RAPID UPDATE

Rapid Update 668 Grecale – Door Seals Check

DATE: NOVEMBER 29 2023

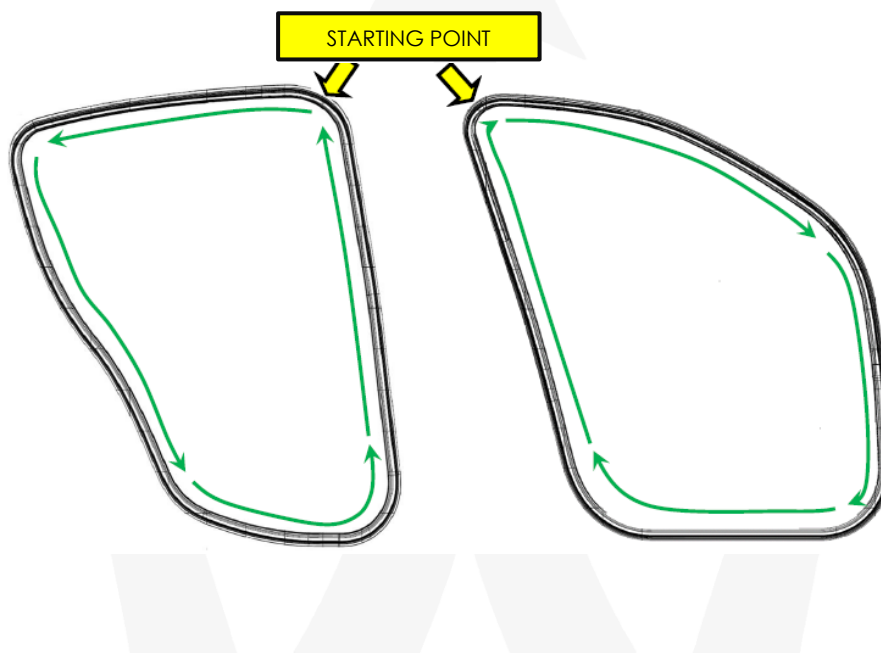
Open the vehicle door and, starting at the top of the "B" pillar, insert your fingers between the tube and the car's body. Gently separate the tubular component outward, as illustrated in the figure below.

2. Run your fingers across the inside area of the tubing all along the vehicle door to check for discontinuities and/or holes in the seal.

- **OK ►** No defects or breakages are found; the gasket can be considered compliant. No further action needed.
- **NOT OK ►** Breakages and/or cuts found in the tubing. Gasket is **not compliant** and must be replaced.
